United States Nuclear Regulatory Commission Official Hearing Exhibit		
In the Matter of: POWERTECH USA, INC. (Dewey-Burdock In Situ Uranium Recovery Facility)		
	ASLBP #: 10-898-02-MLA-BD01	Identified: 8/19/2014 Withdrawn: Stricken:
	Docket #: 04009075	
	Exhibit #: APP-016-C-00-BD01	
	Admitted: 8/19/2014	
	Rejected:	
Other:

Revised Responses to TR RAIs Dated May 28, 2010**Meteorology****TR RAI 2.5-1**

Figure TR RAI 2.5-1c-1: Newcastle 9-Year and 1-Year Wind Roses

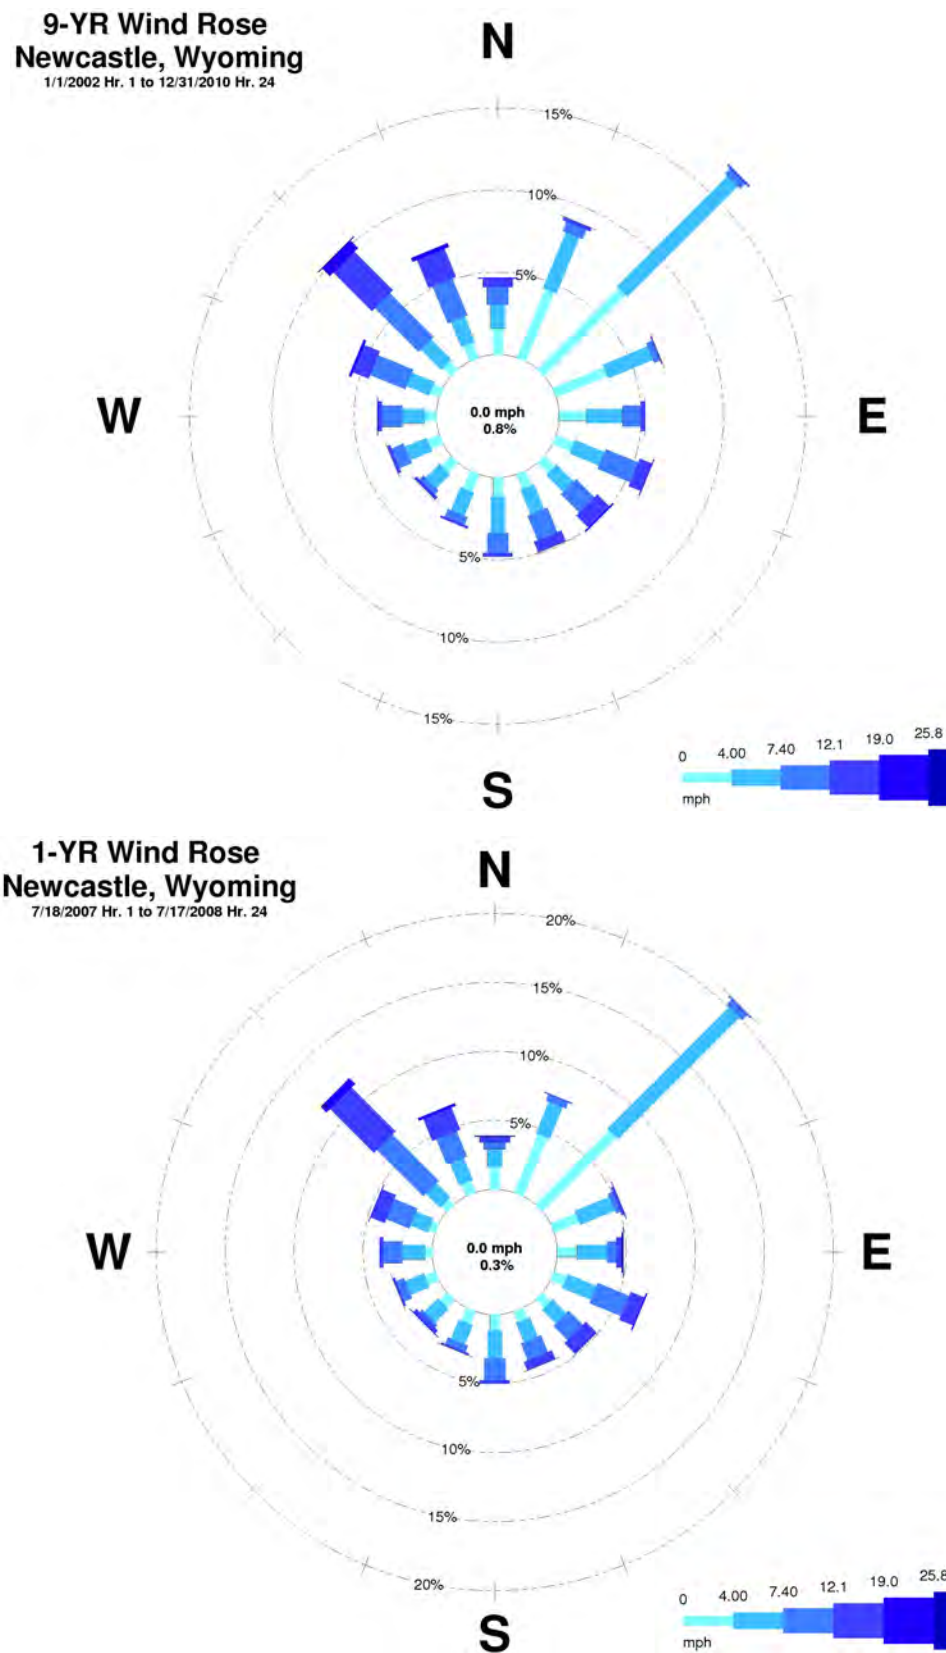
Regulatory Guide 3.63 recommends comparing a concurrent period of meteorological data from a National Weather Service (NWS) station with the long-term meteorological data from that NWS station. The NWS station selected for this comparison should be in a similar geographical and topographical location and be reasonably close (preferably within 50 miles) to the site. Regarding the long-term representativeness of the data collected onsite, please address the following issues.

TR RAI 2.5-1

Figure TR RAI 2.5-1c-1 shows wind roses at the Newcastle station for the nine full years of monitoring and for the one year corresponding to the Dewey-Burdock baseline monitoring period. Figure TR RAI 2.5-1c-2 presents a graphical comparison of short and long-term wind direction distributions. Both figures demonstrate qualitatively that the period from 7/18/2007 to 7/17/2008 is representative of the longer term.

Figure TR RAI 2.5-3-1: Comparative Atmospheric Stability Methods for Dewey-Burdock

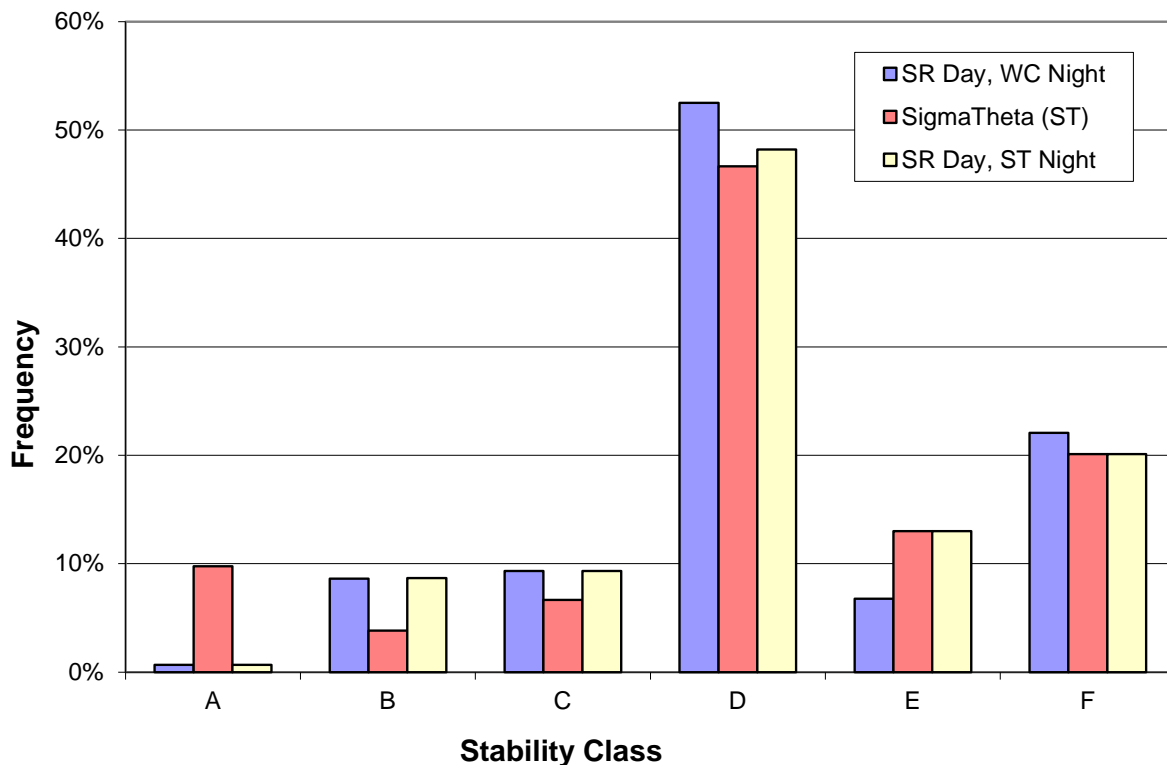
Regulatory Guide 3.63 recommends that quarterly and annual wind direction, wind speed, and atmospheric stability data be compiled in joint frequency and joint relative frequency (i.e., decimal frequency) form for heights representative of effluent releases. In addition, stability categories should be established to conform as closely as possible with those of Pasquill. Please provide this data consistent with Regulatory Guide 3.63 or provide justification for an alternate methodology.

Having developed these hourly σ_{θ} values, the choice remained whether to use the sigma theta method exclusively, or to use a hybrid method that takes advantage of solar radiation (SR) data during the daytime. To facilitate this choice, the two methods were compared along with the original method which used SR during the day, and assumed worst-case delta-T (WC) at night. Figure TR RAI 2.5-3-1 shows the results of this comparison.

Figure TR RAI 2.5-4-2: Corrected Dewey-Burdock Annual Wind Rose

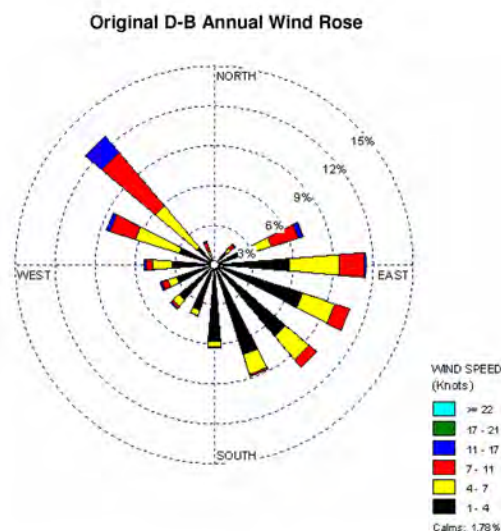
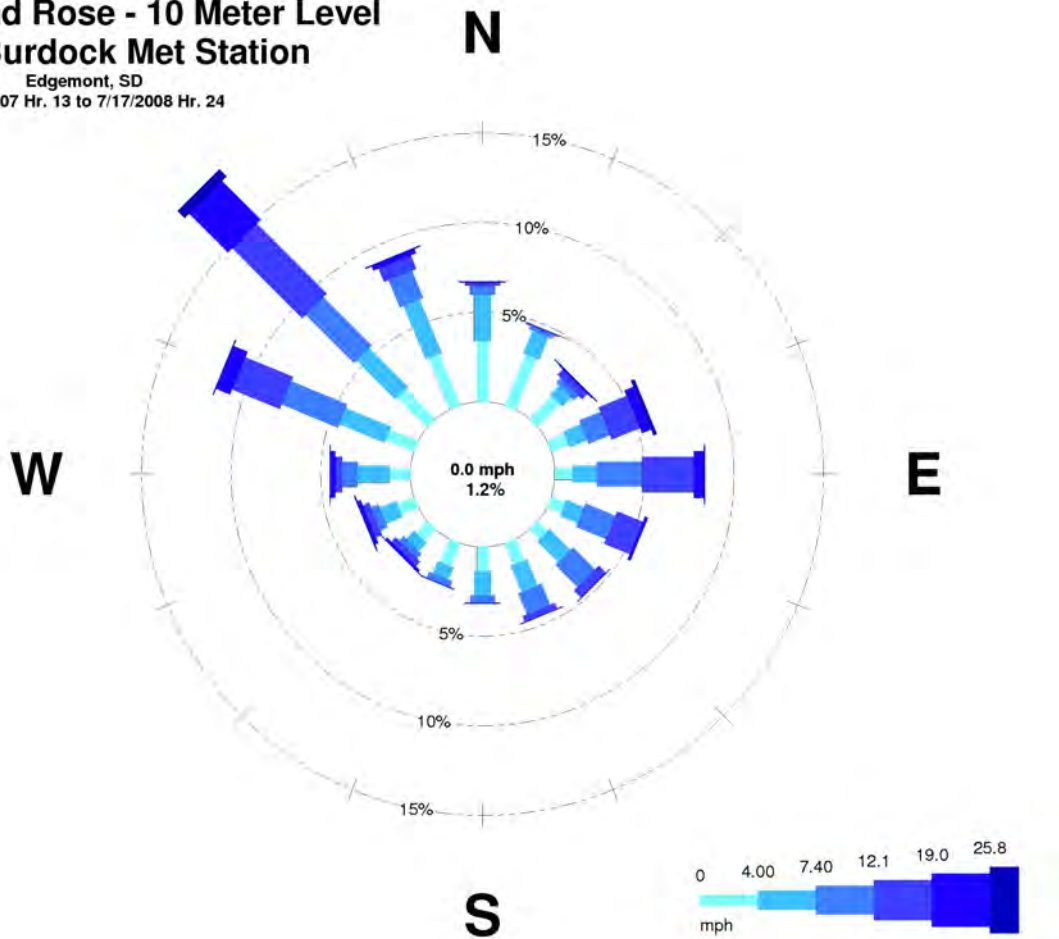
Consistent with Regulatory Guide 3.63, please provide an annual wind rose summary for the 16 compass directions for the project site.

The correct method of calculating wind direction requires computation of vector averages and can lead to different results than wind directions calculated using an arithmetic average, particularly for winds trending out of the north. To illustrate, if half of the 5-minute averages for a particular hour show 359° and the other half show 1°, the vector average will produce 0° (true north) while the arithmetic average will produce 180° (true south). The result of this error was a wind rose that under-accounted for northerly winds and over-accounted for southerly winds (Figure TR RAI 2.5-4-1).

Figure TR RAI 2.5-4-2 contains the adjusted annual wind rose for Dewey-Burdock at the 10-meter height, based on vector averaging of the 5-minute wind directions. It resembles Figure TR RAI 2.5-4-1, except for the NNW, N, NNE, and S directions.

Figure TR RAI 2.5-4-3: Corrected Dewey-Burdock 1st Quarter Wind Rose

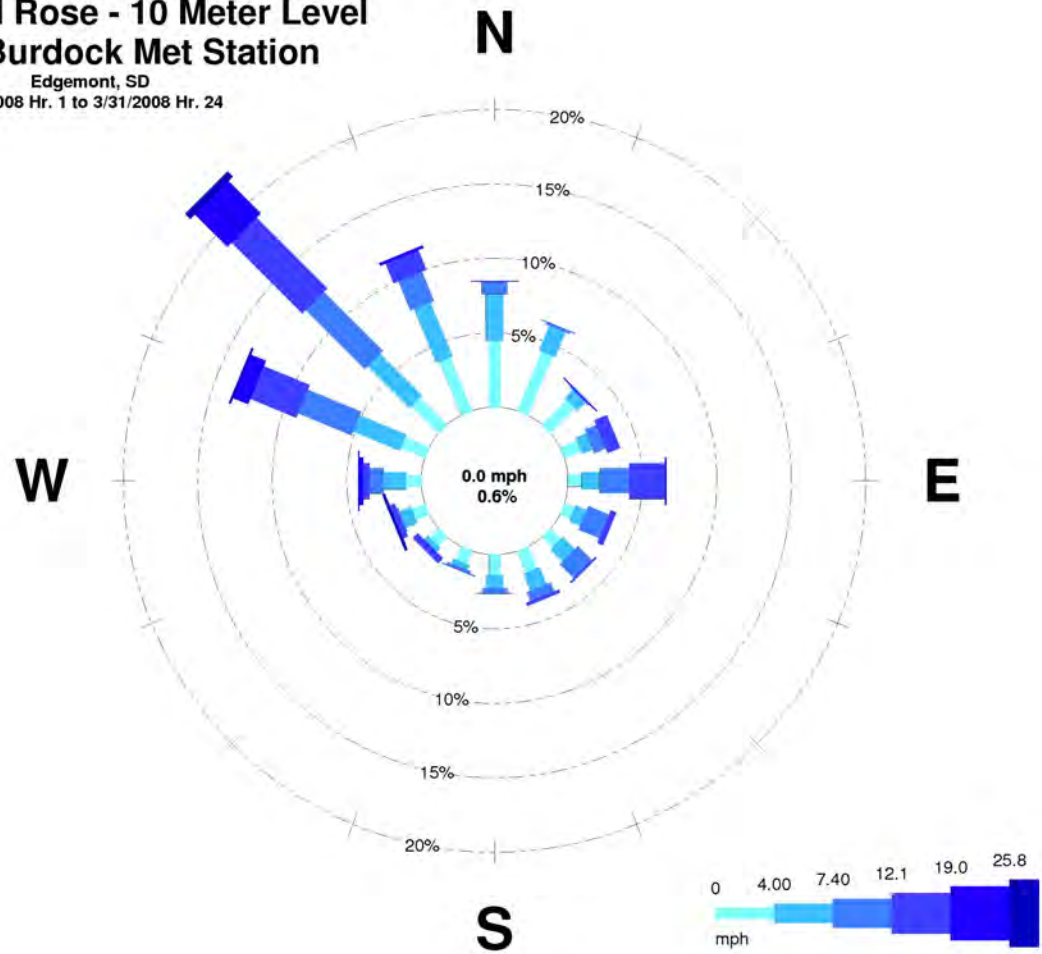
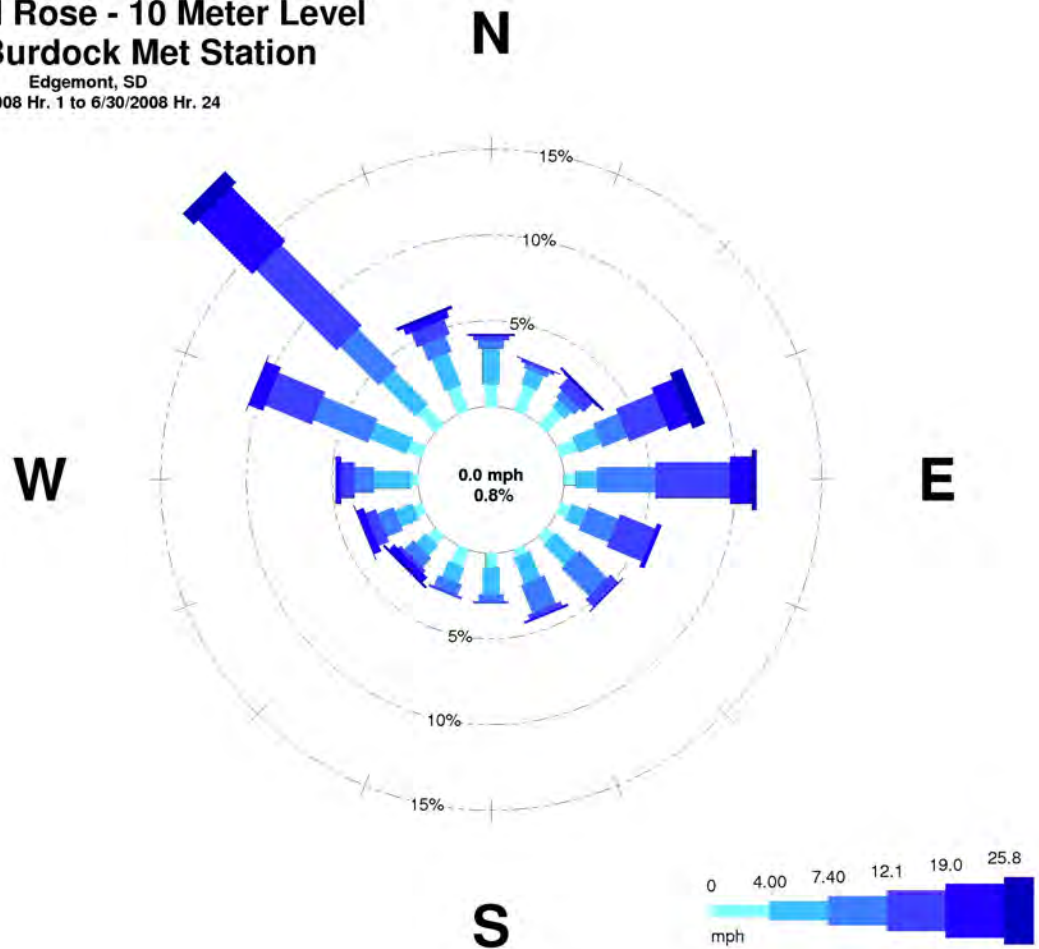
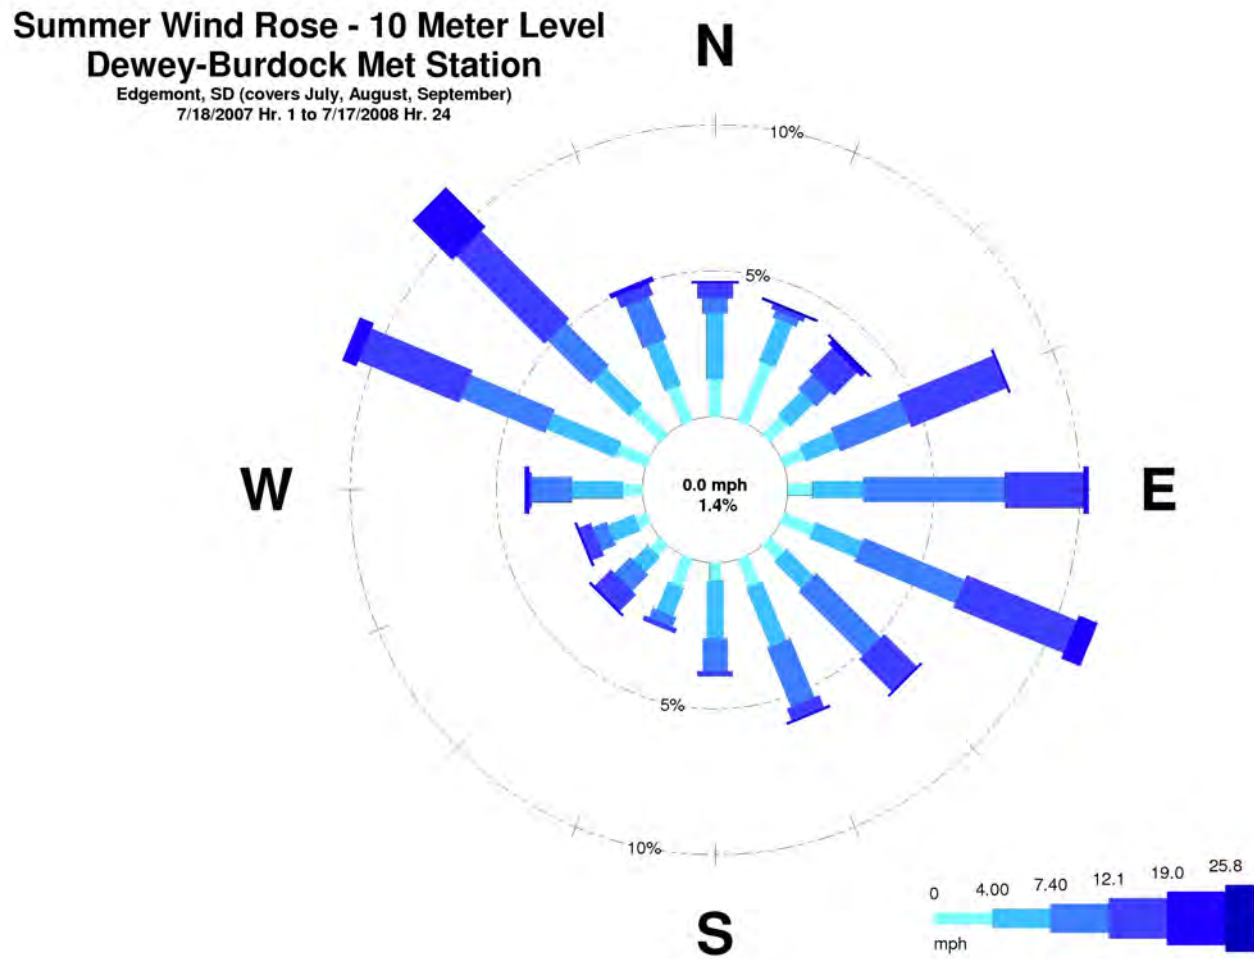
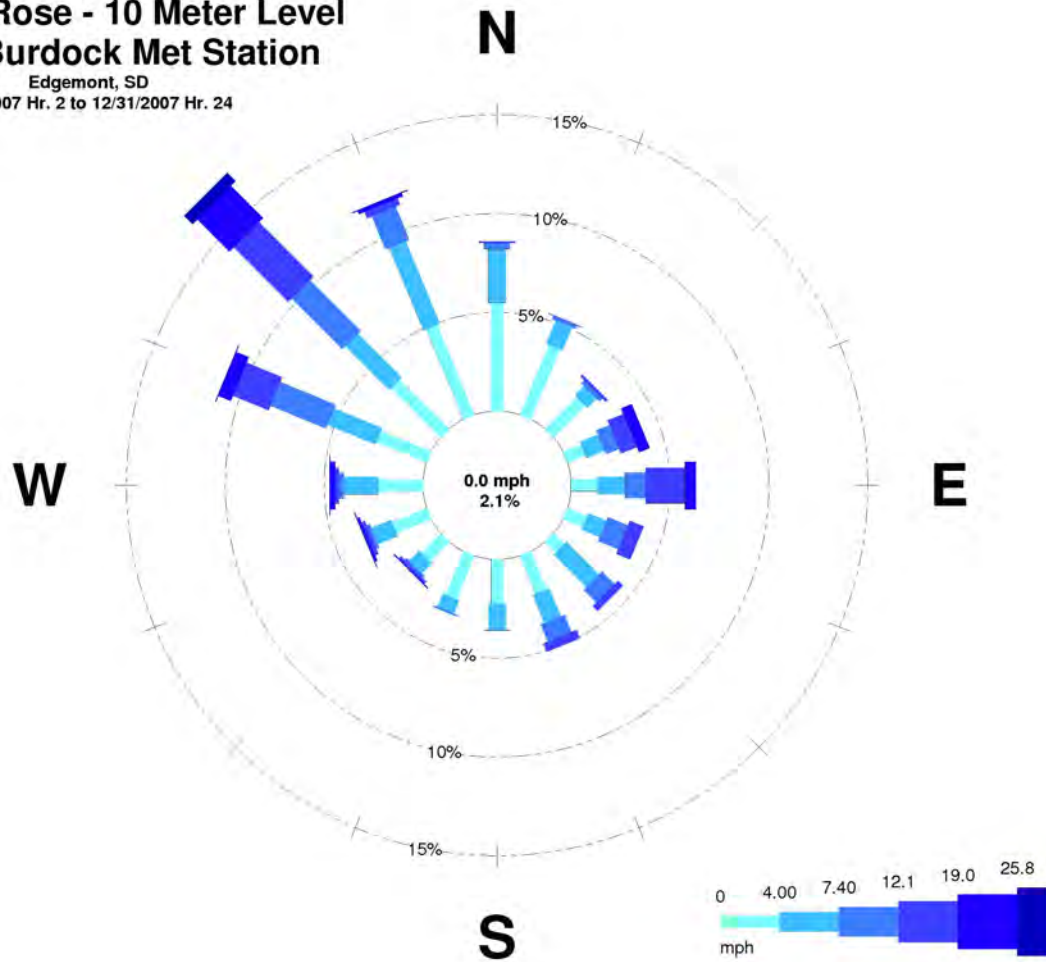
- b. Also on page 2-83, the applicant discusses wind data for the months of May and December. However, this data cannot be confirmed because the data in Table 2.5-7 appears to be a yearly tabulation while the data in Figures 2.5-22 and 2.5-23 are seasonal. Please provide data to confirm the applicant's statements for wind data.***

Figures TR RAI 2.5-4-3 through TR RAI 2.5-4-6 show the quarterly wind roses for the Dewey-Burdock project area, also at the 10-meter height. The period from January through March was used for the 1st Quarter, April through June for 2nd Quarter, July through September for 3rd Quarter and October through December for 4th Quarter. The summer wind rose reflects hourly data from both 2007 and 2008.

Figures 2.5-22 and 2.5-23 in the TR have been replaced by Figures TR RAI 2.5-4-3 through TR RAI 2.5-4-6 in the response to TR RAI 2.5-4. The revised figures show the quarterly wind roses for the Dewey-Burdock project area at the 10-meter height. The period from January through March was used for the 1st Quarter, April through June for 2nd Quarter, July through September for 3rd Quarter and October through December for 4th Quarter. The 3rd quarter wind rose reflects hourly data from both 2007 and 2008.
